Mobile Intel[®] Celeron[®] Processor at 466 MHz, 433 MHz, 400 MHz, 366 MHz, 333 MHz, 300 MHz, and 266 MHz Specification Update

Release Date: July 2002

Order Number: 244444-034

Figure 2. Workaround Flowchart: SMBALERT#-Driven System

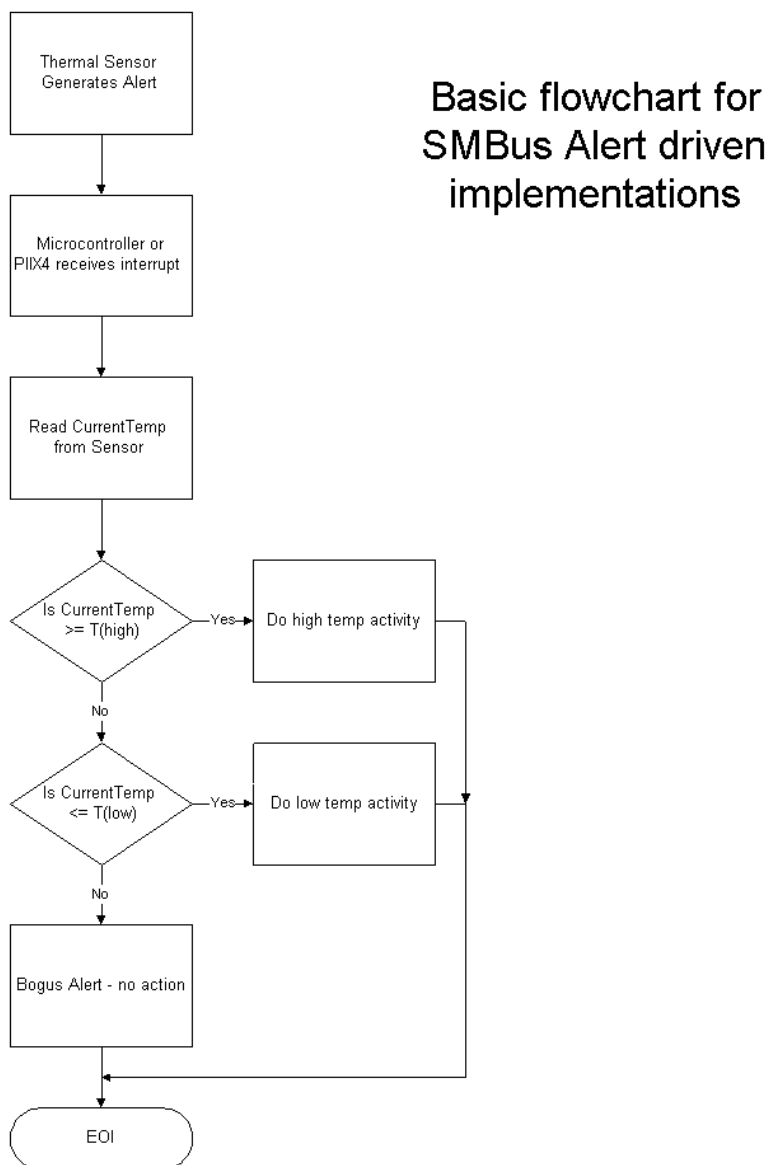
H29. Thermal Sensor May Assert SMBALERT# Incorrectly

Problem: The Intel Celeron Processor Mobile Module has a thermal sensor that monitors the processor core's temperature. Please note that desktop systems could have a similar thermal device. The thermal sensor asserts SMBALERT# if the processor temperature exceeds the temperature limits set in the Alarm Threshold Registers (T_{HIGH} , T_{LOW}). It also sets the corresponding Status Register bits to identify the cause of the interrupt. Figure 1 gives one example of the how the SMBALERT# signal could be used in a system.

Workaround: Three different (mutually exclusive) workarounds are possible:

1. Before servicing an interrupt from the thermal sensor, read and compare the processor thermal reading with the threshold limits (T_{HIGH} or T_{LOW}). Figures 2 and 3 provide basic flowcharts for the implementation of this workaround in an interrupt driven system.
2. If the firmware implemented polls the Status Register only, then before taking any action, re-read the temperature register and do a comparison with the alarm threshold limits (T_{HIGH} or T_{LOW}) to determine if the value is actually still within the temperature window.
3. Use a temperature polling scheme to monitor the processor temperature.
